SUBMITTAL OF COMMITMENT RESOLUTION INFORMATION
DOCKET NO. 72-22 / TAC NO. L22462
PRIVATE FUEL STORAGE FACILITY
PRIVATE FUEL STORAGE L.L.C.

RAI's 2-1 & 2-2 (second round), Geotechnical Program

PRIVATE FUEL STORAGE FACILITY
PRIVATE FUEL STORAGE, LLC
SOIL PROPERTIES VS DEPTH
IN STORAGE PAD AREA
SHEET 1 OF 2

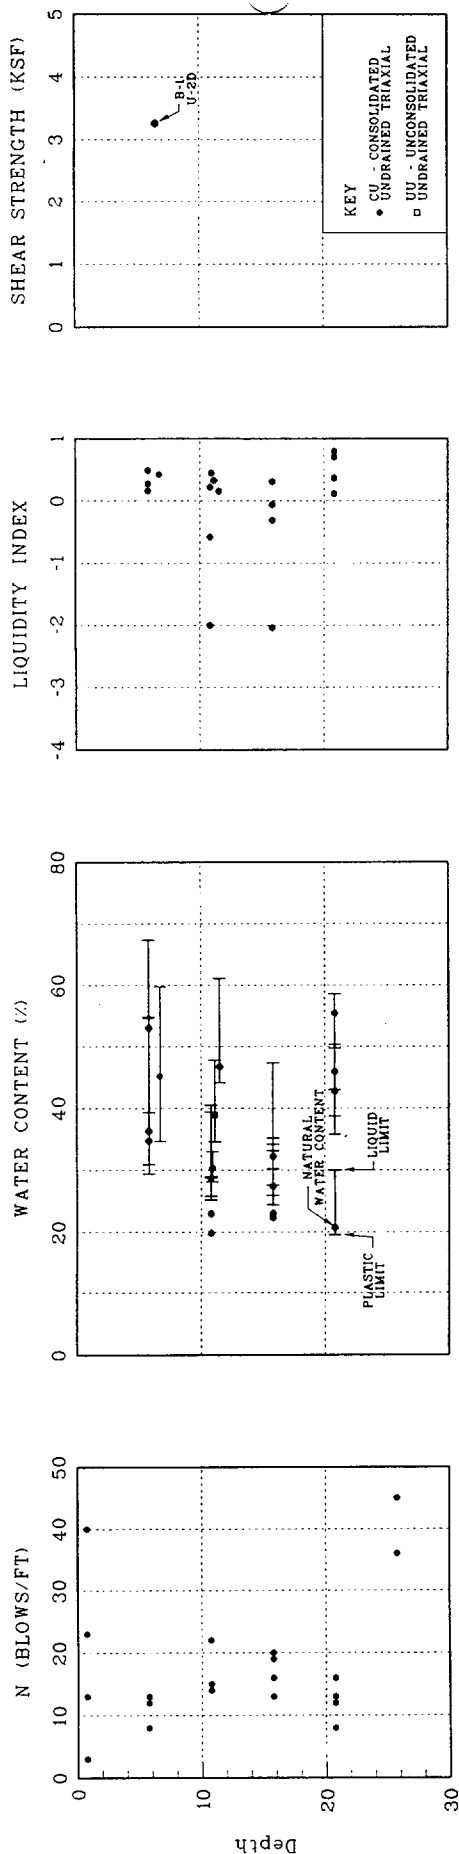
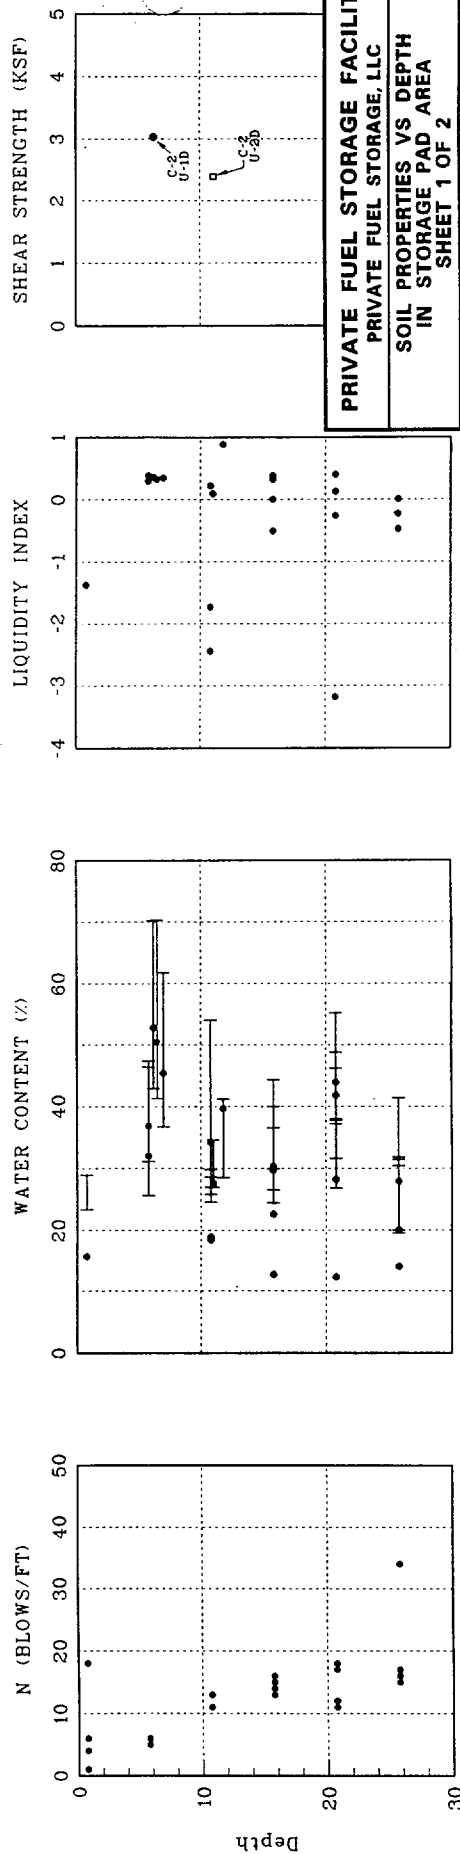
NRC Comment – The PFS field geotechnical investigation program is limited in the number of borings and tests provided. PFS should perform an evaluation of the Standard Penetration Test blow counts (N-values), individually, rather than averaged over 5-ft intervals, to demonstrate that the variability in N-values across the site is not significant. Atterberg Limits, shear strength, and compressibility should also be addressed.

These data are plotted in the attached figures, "Soil Properties vs Depth in Storage Pad Area," along with the SPT N-values and the results of the shear strength tests that have been performed to date. Note, two additional consolidated - undrained triaxial tests were performed on undisturbed samples that were obtained in the vicinity of the Canister Transfer Building, approximately 150 ft northeast of Boring D-4. These data also are included on the attached figures to present all of the available strength data vs depth that has been obtained near the pad emplacement area.

This matrix and these figures illustrate that the soils in the upper layer of the profile do not vary significantly across the site. Shear strength data are provided for samples obtained from depths of 5 to 7 ft and 10 to 12 ft. As can be seen on these figures, the

Therefore, it is concluded that these data demonstrate that the soils in the upper layer are uniform across the site and there is not sufficient variability in the blow counts to justify requiring individual design parameters for each pad. In addition, the strength and compressibility testing that have been performed provide conservative estimates of the strength and compressibility of the deeper soils within the upper layer.
